Rickman's Green Village - Phase 2

Planning Application Ref: 22/03131/OUTEIA
(Up to 492 dwellings and 2FE Primary School)

Further Objections on Highway and Transport Grounds

Plaistow and Ifold Parish Council

Diagram 1

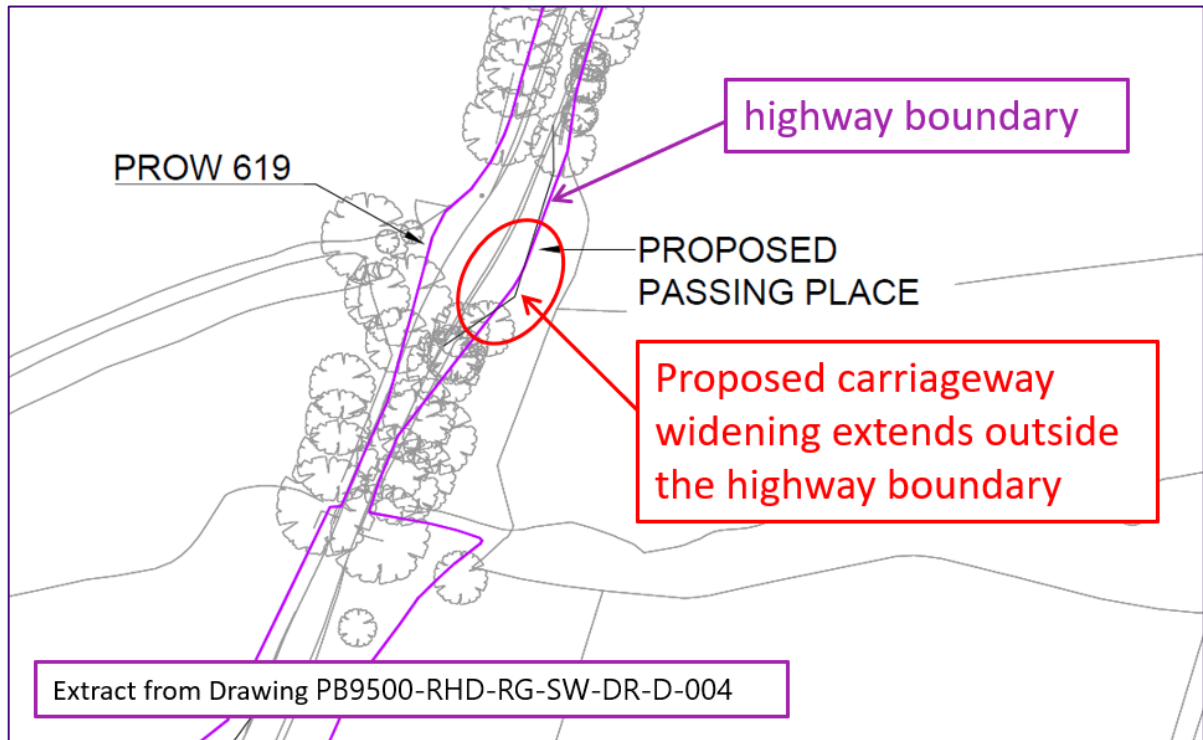
2.3.10 The applicant proposes the construction of six passing places on Foxbridge Lane. These are shown on Drg PB9500-RHD-RG-SW-DR-D-004 in Annex A. The proposals shown are indicative designs based on two-dimensional OS mapping rather than a three-dimensional topographical survey. Verge widths are very narrow throughout the northern section of the lane and there are significant level differences at the carriageway edge. The presence of highway ditches and trees along the highway boundaries also needs to be considered. Further design work is needed by the applicant to confirm the practical feasibility of carrying out the construction works and the resulting visual and landscape impacts.

2.3.14 It is also noted that one of the passing places, opposite PROW 619 extends into third party land, beyond the highway boundary, as shown in the diagram below. It is unclear if this is a drafting error or if the applicant has secured control over the land needed for this passing place.
